From: Will Teass <will@TEKTONICS.COM>
Sent: Monday, May 21, 2012 7:32 PM
To: Scala, Mary Joy
Cc: Walden, Ebony
Subject: RE: Preston Place: Building Permit / Historic Review

RE: Certificate of Appropriateness Application
BAR 12-03-07
600 Preston Place
Tax Map 5 Parcel 109
Will Teass, AIA, Applicant/ Xi Chapter of Theta Chi Alumni Corp, Owner
Revisions to approved design

THETA CH1 - XI CHAPTER ADDITION

600 PRESTON PLACE

PROPOSED SITE PLAN
1" = 10'-0"

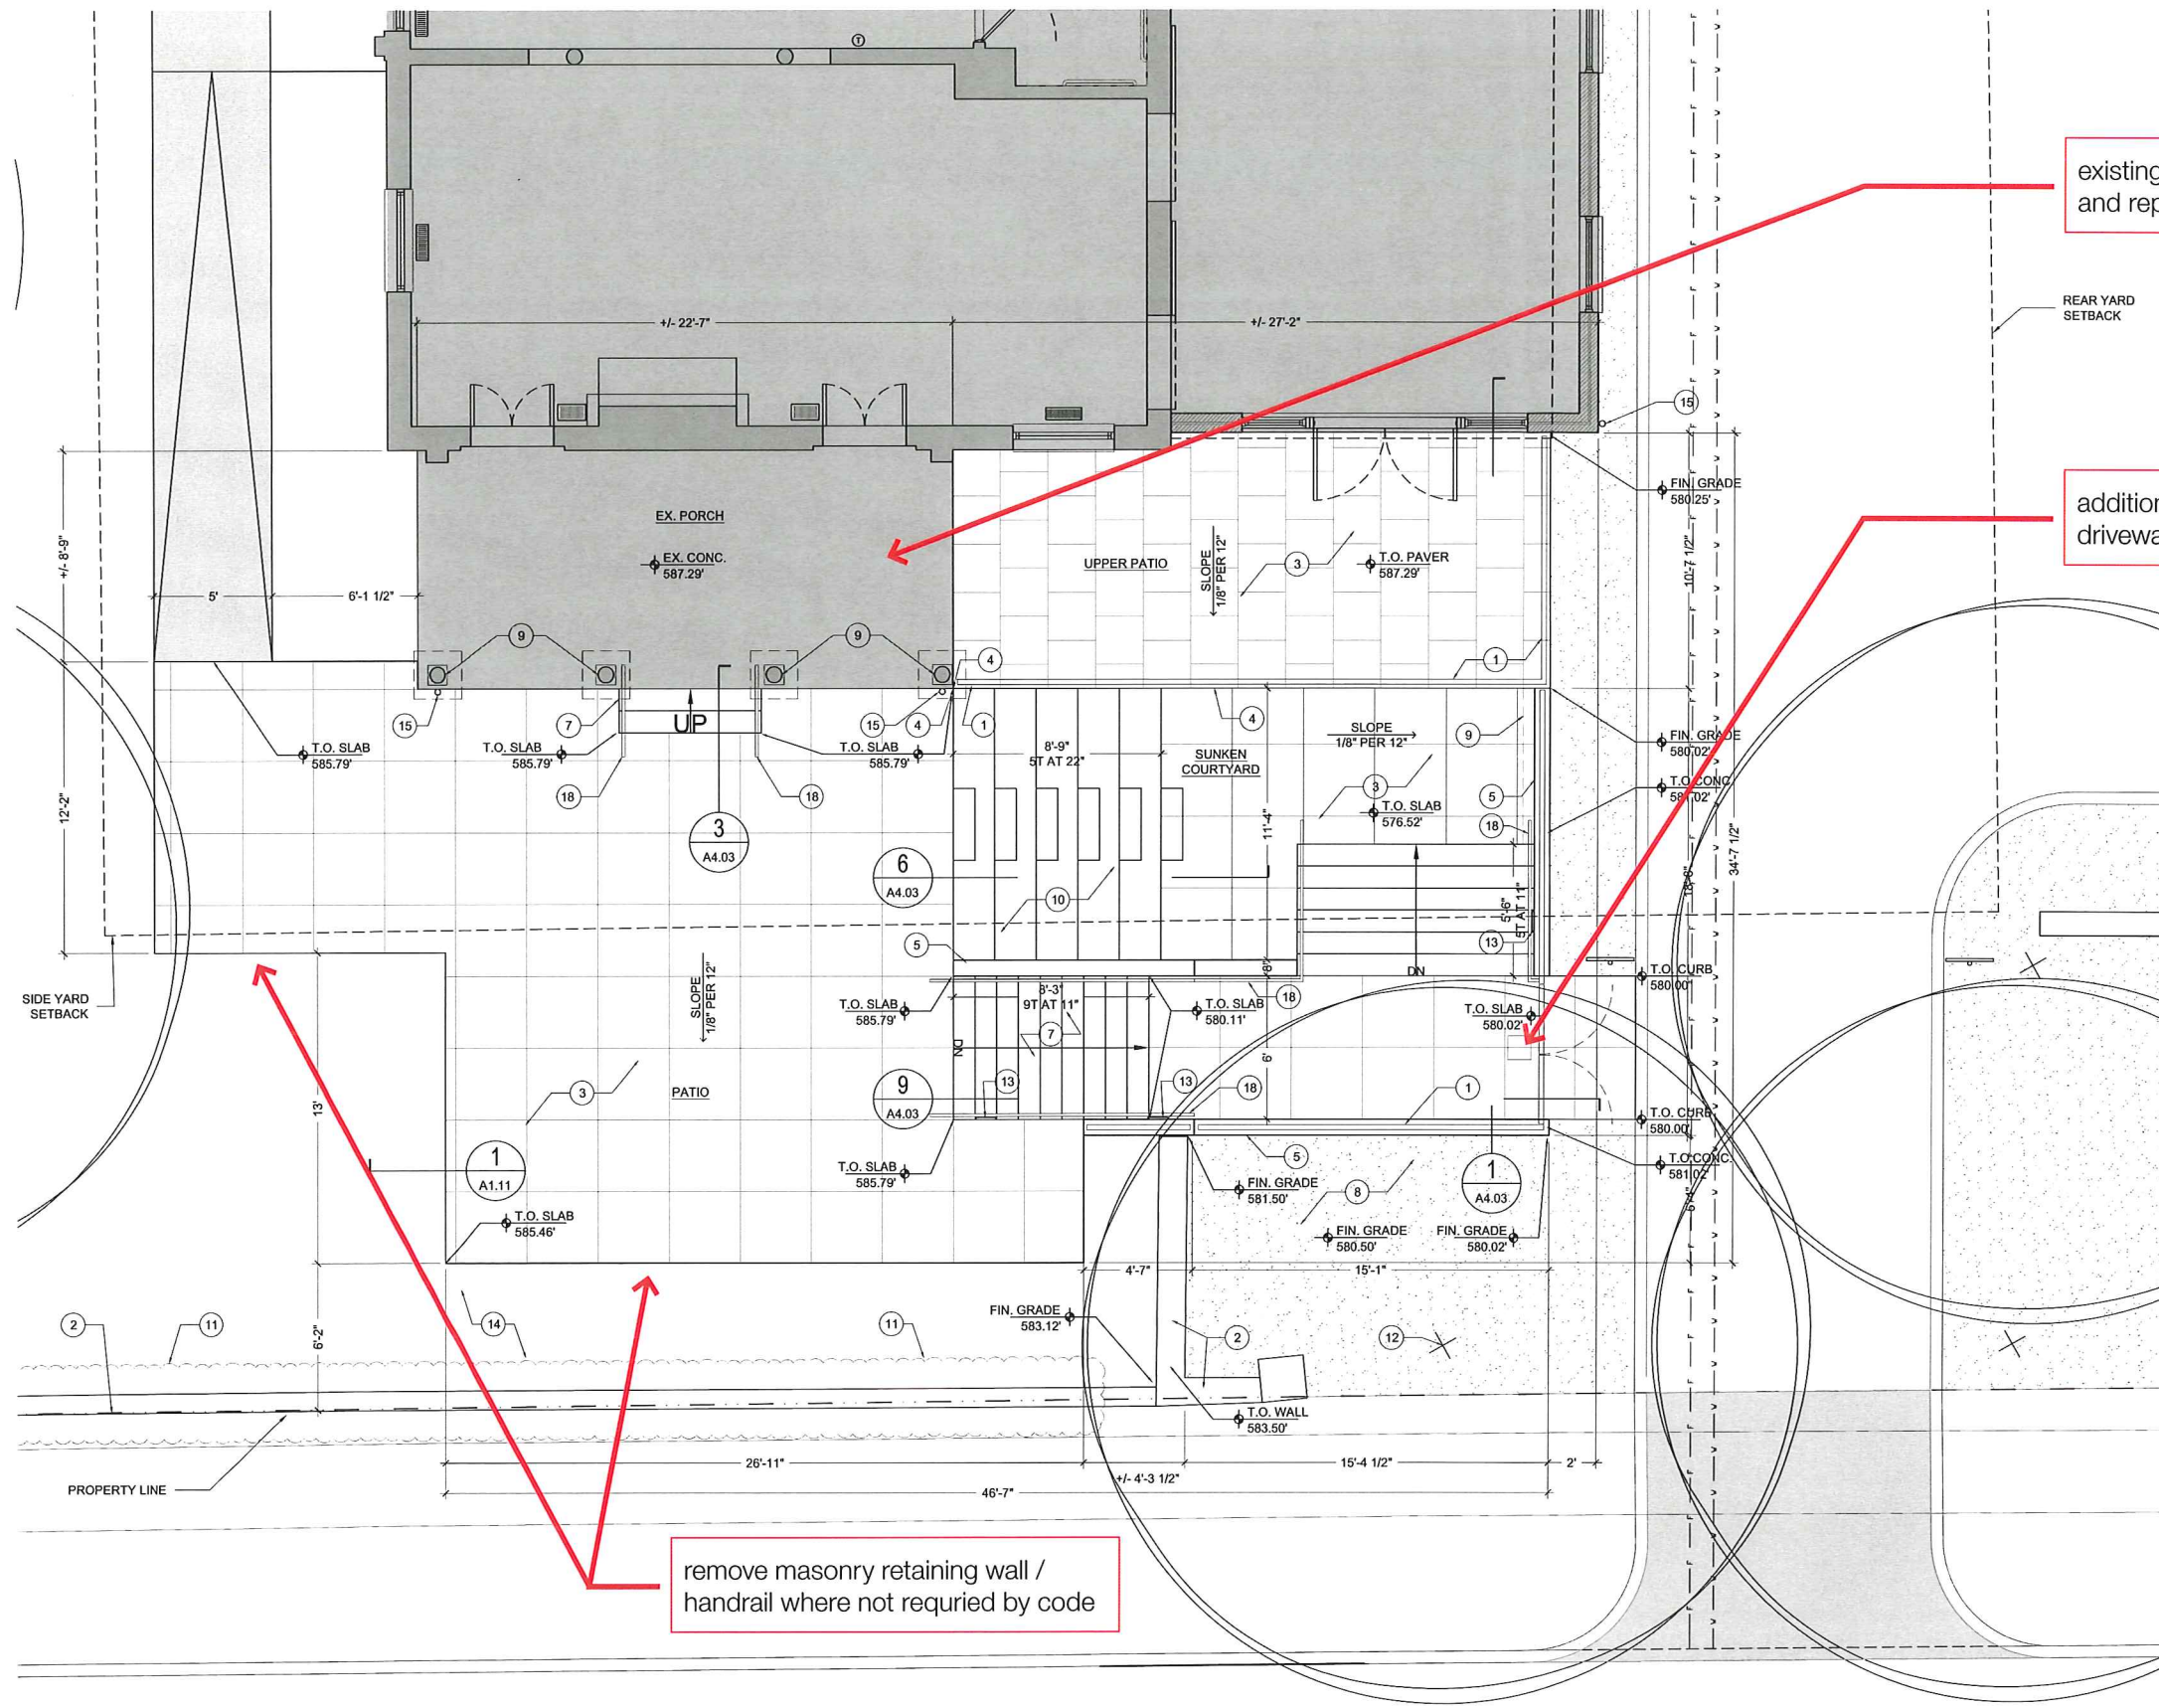
Pursuant to site plan comments, the configuration of the accessible route was modified and the masonry screen wall is closer to Preston Place. Additionally, the Owner would like to use split-face CMU in lieu of brick on the parking screen walls. Also the trash enclosure was enlarged to accommodate up to 2 of the mechanical units behind the wall.

Previous submissions included two areas of permeable pavers at each of the north and east parking areas, as well as paver areas at the driveway entrances. In order to reduce project cost, we are proposing to use large underground storage structures and use asphalt in lieu of the porous concrete.

split-face cmu at parking screen walls in lieu of brick veneer

reconfigured accessible route

remove permeable pavers / porous concrete at parking areas

enlarged trash enclosure to screen mechanical units

additional pedestrian entrance at driveway

- 1. Reconfigured HC route;**
- 3. Trash enclosure screen enlarged to accommodate mechanical units.**
- 5. Add second pedestrian entrance to patio.**
- 6. Remove masonry retaining wall/handrail from patio where not required by Code.**
- 7. The existing concrete porch slab will be removed and replaced.**
- 8. Substitute Pella Proline aluminum clad windows with exterior affixed SDL's for Marvin windows. Replacement and new French doors will be painted wood with true divided lights.**
- 9. Substitute HardieTrim for Miratec.**

- 4. Underground storm water storage/asphalt is substituted for use of porous pavers.**

- 2. Brick veneer parking screen walls changed to split face CMU at both locations Grady and at Preston Place. Also, denied was the revision to change the casement windows on the second floor sleeping porch to double-hung windows.**

LAYOUT PLAN
1/4" = 1'-0"

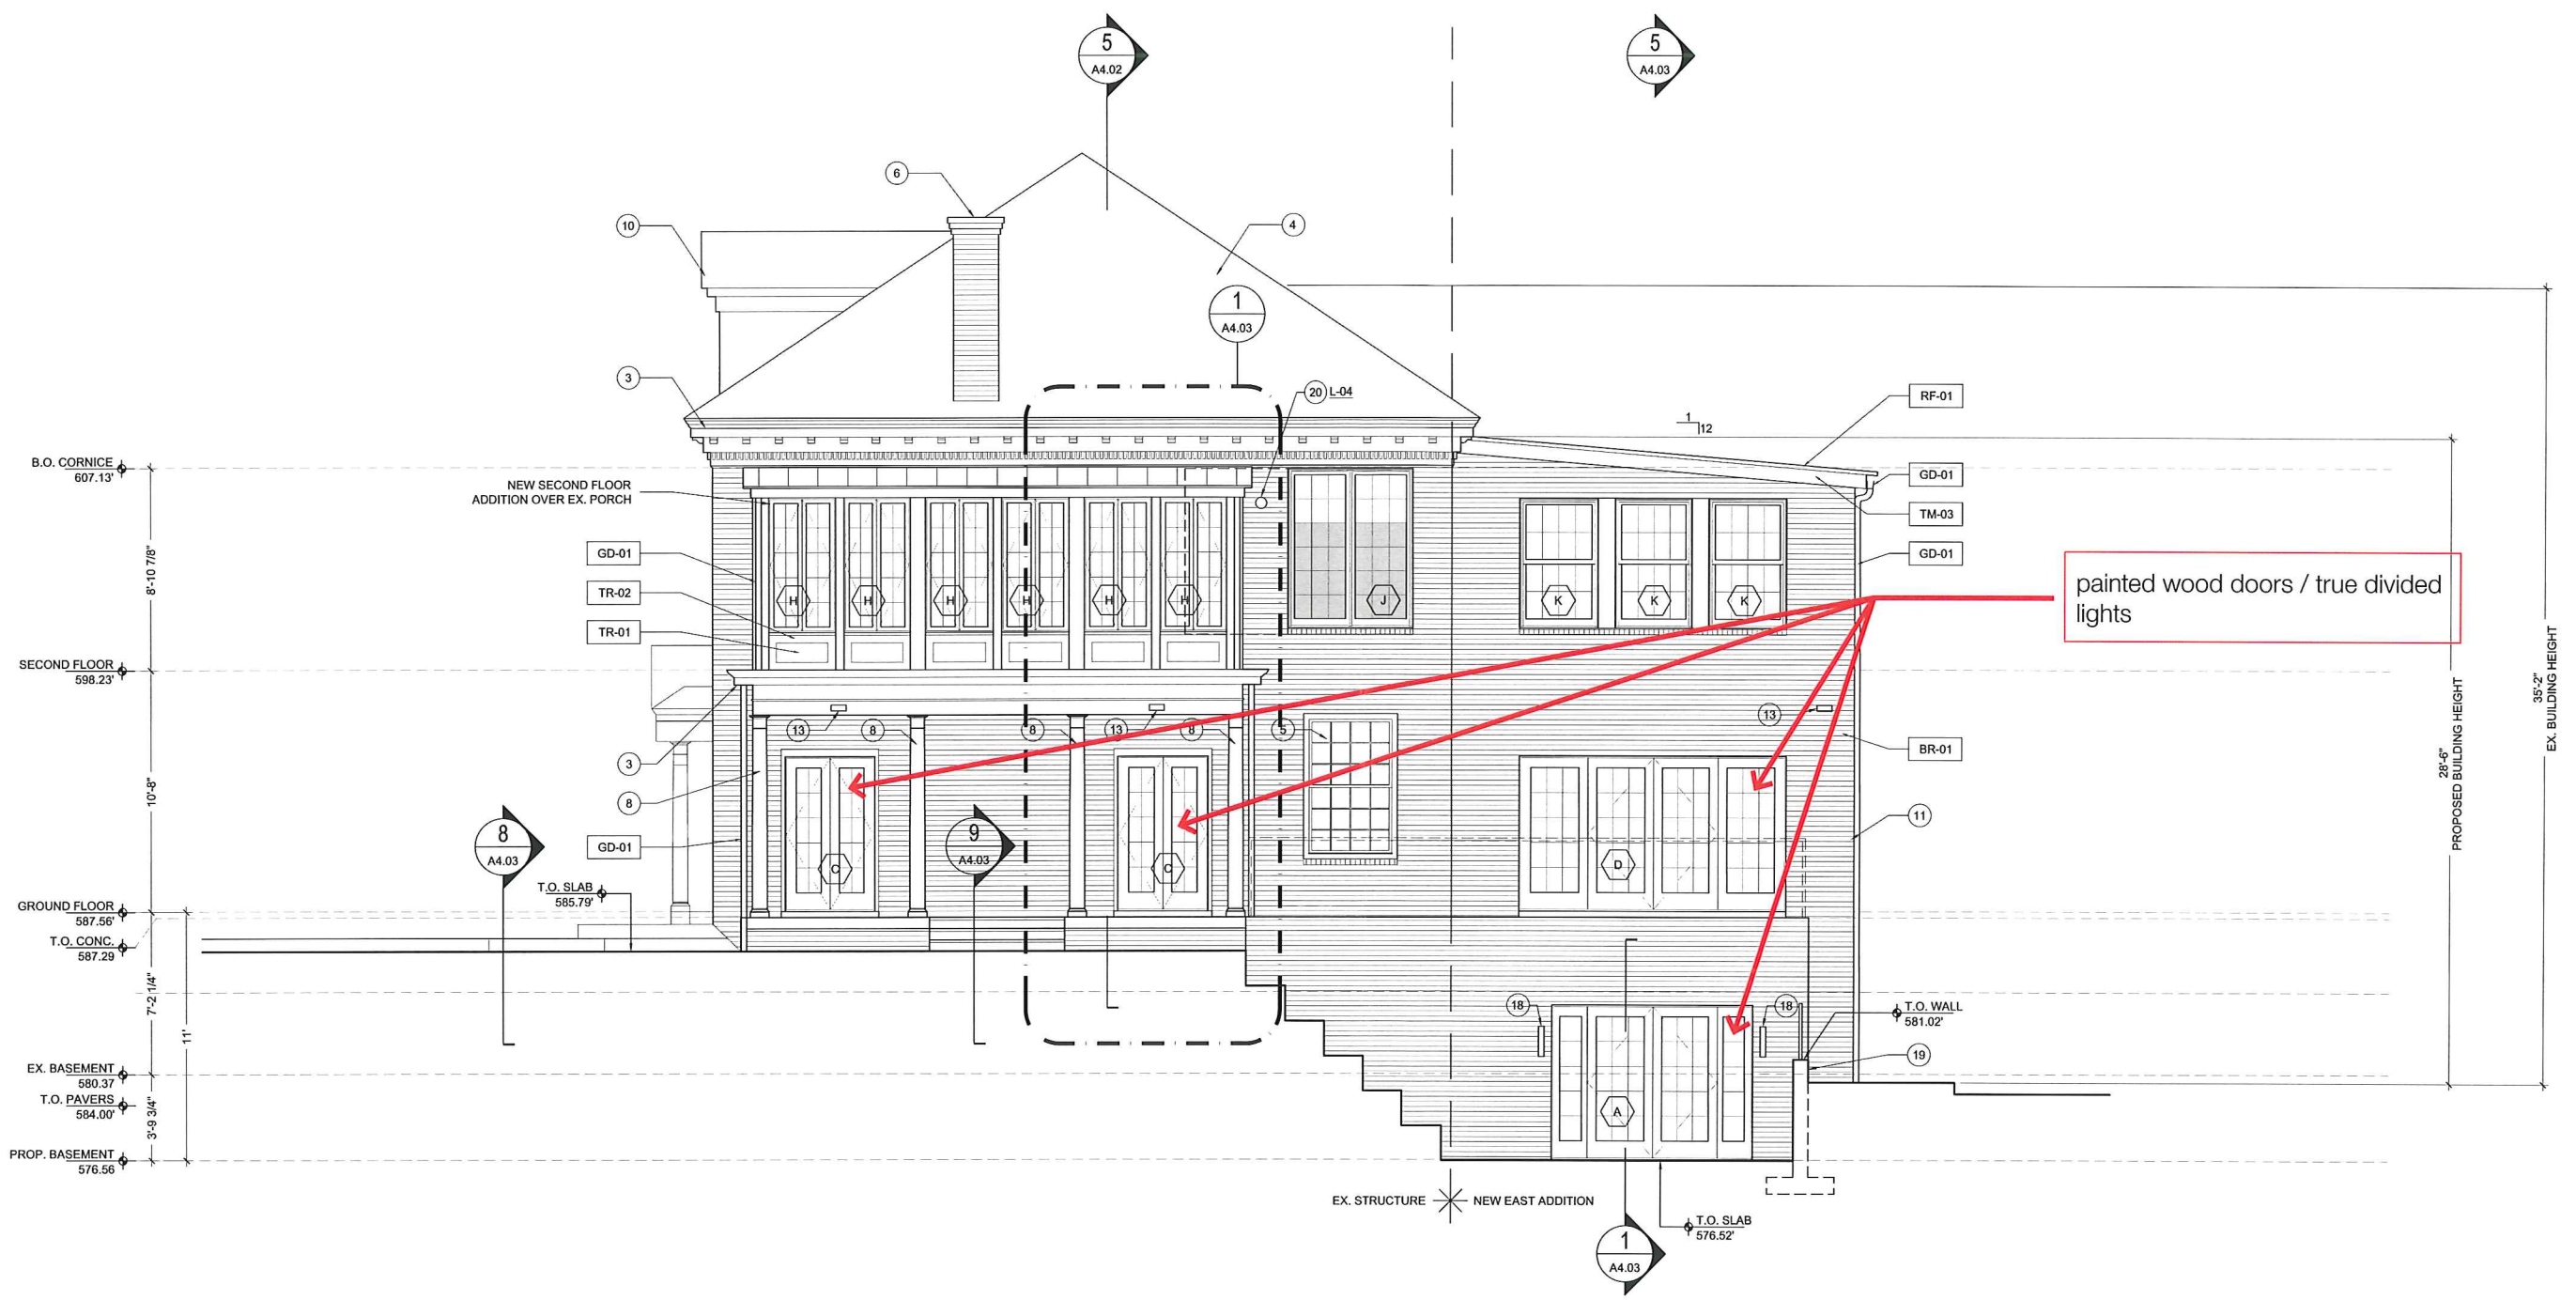
The original proposal included a single patio entrance at west patio entrance; the Owner has requested that the design team add a second pedestrian entrance on the east side, facilitating access to the east parking area. Additionally, the partial height masonry wall and metal guardrail has been removed to reduce site costs. The existing concrete porch slab will be removed and replaced.

existing porch slab to be removed and replaced with new slab

additional pedestrian entrance at driveway

remove masonry retaining wall / handrail where not required by code
